Our reference: P-358914-D1J5
Contact: Gavin Cherry
Telephone: (02) 4732 8567

**ARDEX Warehouse and Manufacturing Facility - Response to Submissions
- SSD-25725029 - 657-769 Mamre Road, Kemps Creek**

Figure 1: Landscape plan

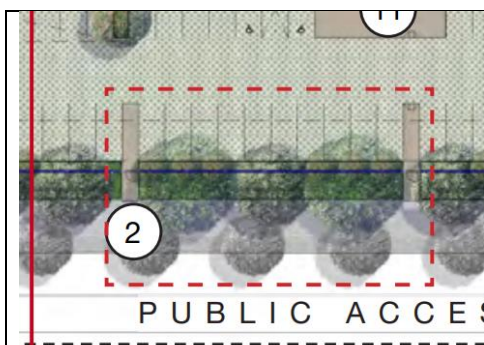
The proposal does not comply with the requirement of the MRP DCP to provide 1.5m wide island planter beds at 10 car space centers as planter beds adjacent to car spaces 61 and 71 (see below at Figure 1 and 2) are proposed to be hardstand pedestrian entry ways.

The row spanning space 107 to 120 is to be amended to comply with the DCP and a 1.5m wide island planter bed is to be introduced (see relevant areas in Figures 1-4 below).

It is recommended that the car parking layout be amended to ensure compliance and that island tree planters are not used for pedestrian entryways.

Figure 5: Architectural plan – Unclear what dashed line indicates – possible impact on landscaping to be clarified/addressed.

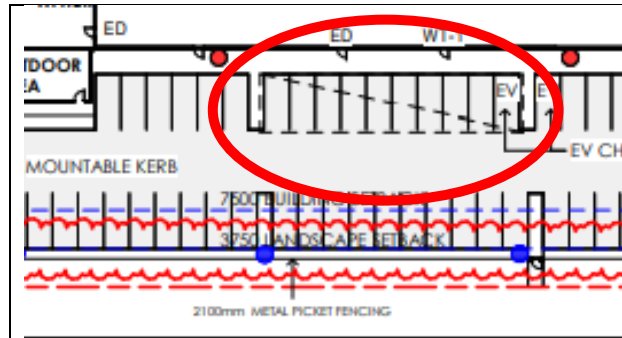
- (g) Design matters – The quality of the design of the office and cladding treatment to the warehouse and silos are to be elevated noting the requirement of the DCP for a world-class precinct with high quality materials, articulation and cladding incorporated.
- (h) Clarification required - It is unclear what the dashed line is indicating (see Figure 5 below). If this is an awning or pit/service area below, it is to be reduced so as not to impact on the tree plantings either side – or tree planting pits increased to ensure canopy/planting is sustainable.
